**WMCPDR – ROLESVILLE, WENDELL, ZEBULON WATERSHED MANAGEMENT  
 CONSTRUCTION PLAN DISAPPROVAL AND REVIEW COMMENTS**

<b>Project Name</b>	Merritt Reserve Subdivision	<b>Watershed</b>	Buffaloe Creek	<b>Jurisdiction</b>	Rolesville
<b>Date Received</b>	04/25/2025	<b>Date Processing Initiated</b>	04/25/2025	<b>Disturbed Acreage</b>	131.22 Acres
<b>S&amp;E Permit Number</b>	SEC-145177-2025	<b>S&amp;E Plan Review Fee</b>	\$32,805.00 PAID	<b>S&amp;E Permit Fee</b>	\$32,805.00 PENDING
<b>SW Permit Number</b>	SWF-145398-2025	<b>SW Plan Review Fee</b>	\$2,500.00 PAID	<b>SW Permit Fee</b>	\$2,500.00 PENDING

**Plan Date/Revision Date:** 04/14/2025

<b>Review Status:</b> 05/19/2025	<input checked="" type="checkbox"/>	<b>Construction Plan Not Approved and Incomplete (Items 1-4 required to be a complete submittal)</b>
	<input checked="" type="checkbox"/>	<b>Construction Plan Not Approved and requires additional information</b>

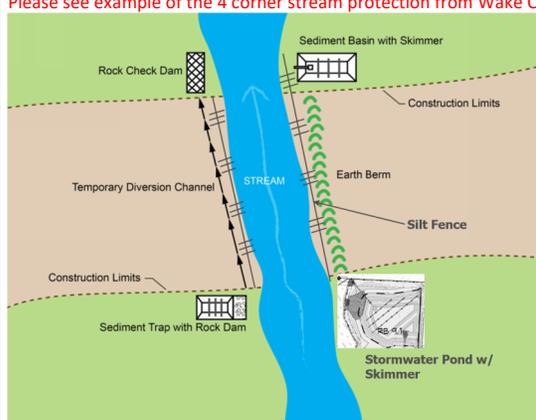
<p>☒ k.</p>	<p>TEMPORARY SEDIMENT CONTROLS: locations and dimensions of gravel entrances, diversion ditches, silt fence, sediment basins, inlet protection, etc.          - Please provide inlet protection at all applicable locations (example shown but not limited to YI 158A).</p>  <p>- Baffle height is to be 2" below spillway, the material of the baffle may vary. Please make baffles a color other than yellow and gray on the plans (hard to see).</p>  <p>- Please provide note that Rolled Erosion Control Product (RECP) needs to be installed on site where the difference in elevation is greater than 10 ft, within basins, and where slopes are greater than 3:1.          - There are 2 extra road entrances on the west side of the project that need to be blocked off.          - Please extend construction entrance length to 100 ft. Add note about length to the detail on sheet CE-500.          - E&amp;SC measures needed on road improvement plan for Rolesville Road (see sheet CT-301).          - Items to include and have an overall timeline for:          - removal of skimmer and baffles          - removing accumulated sediment and re-shaping required contours for volume control requirements          - installing the proper draw down orifice          - notes about timing and method of planting of wetland plants and permanent slope stabilization          - ensuring installation of all conveyances to SCMs, pipe networks, or swales; are lots graded to ponds if required per plan?</p>

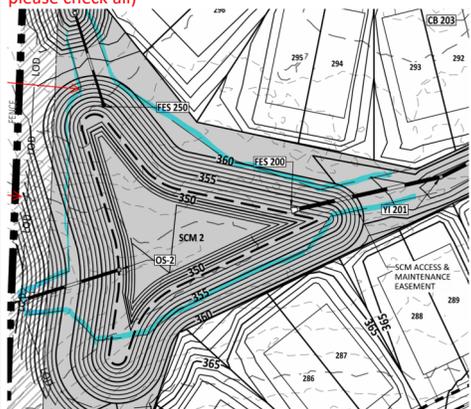
<input checked="" type="checkbox"/>	<p>q.</p>	<p>Location and requirements for stockpiles (see website for <a href="#">Stockpile Requirements</a>) Please confirm and label 25ft width between stockpile and silt fence per Wake County design criteria. Please include maintenance requirements on plan. May need to have more than 1 stockpile/staging and laydown area based on the size of the project site. Please include E&amp;SC measures with all locations.</p>
<input checked="" type="checkbox"/>	<p>r.</p>	<p><a href="#">Wake County Construction Sequence</a> (Provide project specific details as needed).      - Please include a construction sequence for each phase and provide project specific details.      - You can remove the required Wake County construction sequence on sheet G-004.      - Please make clear in the notes that Wake County does not need to be contacted for compliance until all measures are installed.      - May recommend adding a note for contacting Rolesville regarding approval of silt fences/tree fences prior to installation of basins for Wake County.      - Please add "Contact DEQ for removal/dewatering after contacting Wake County for field approval" to the basin removal sequence on G-004.      - Please remove the construction sequence references for Kalas Falls on sheet G-004 and replace with Merritt Reserve.      - Please provide a site specific construction sequence for each SCM on the pond detail sheets, these notes are for the contractor. Please provide permanent stabilization for those slopes.      - Please remove references to Raleigh and replace with Rolesville where applicable.</p>
